RE: Contract No. MA-679-000-002
Upgrade and Replace Existing Signing – Northern Region

ADDENDUM NO. 8

III. The following changes have been made to the contract plans:
   a. Delete Sheets 1, 119, 123, 125, and 156 thru 169, and replace them with the attached sheets numbered the same with Addendum No. 8 notation.

CONTRACT NO. MA-679-000-002
DRAWING NO. SN-8
SHEET NO. 119 OF 169

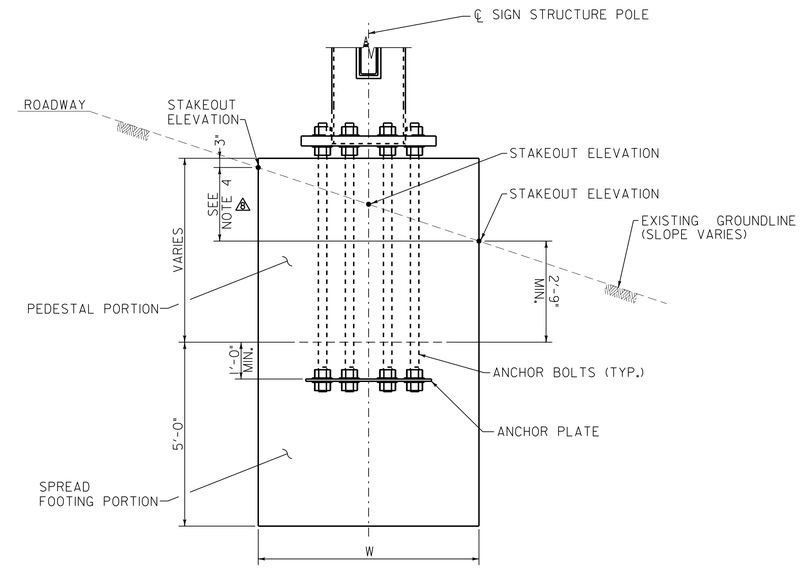
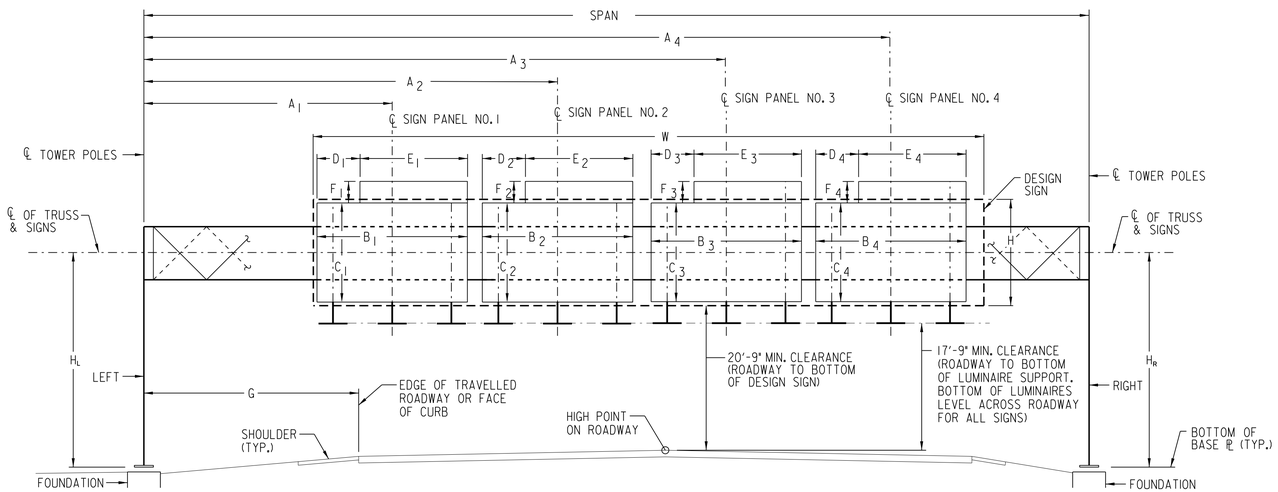
Question: On the sign structure detail sheets (SN-8 & SN-9) you show 2'-9" cover over the foundation. SHA uses 1'-0". Anchor bolts lengths vary without knowing the slope. We cannot bid on price for anchor bolts.

Final response: Related plans and quantity for Item 8033 Concrete for Sign Foundation have been revised in the Addendum No.8.

△8. SEE DRAWING NO. SN-8, OVERHEAD SPAN FOUNDATION - SECTION FOR ADDITIONAL FOUNDATION DETAILS. CHANGE IN GROUNDLINE AT FOUNDATION LISTED BELOW AS "GROUNDLINE △". INFORMATION IS APPROXIMATE ONLY. CONTRACTOR IS RESPONSIBLE FOR VERIFYING INFORMATION THROUGH CONSTRUCTION STAKEOUT IN ORDER TO MEET ALL APPLICABLE REQUIREMENTS.
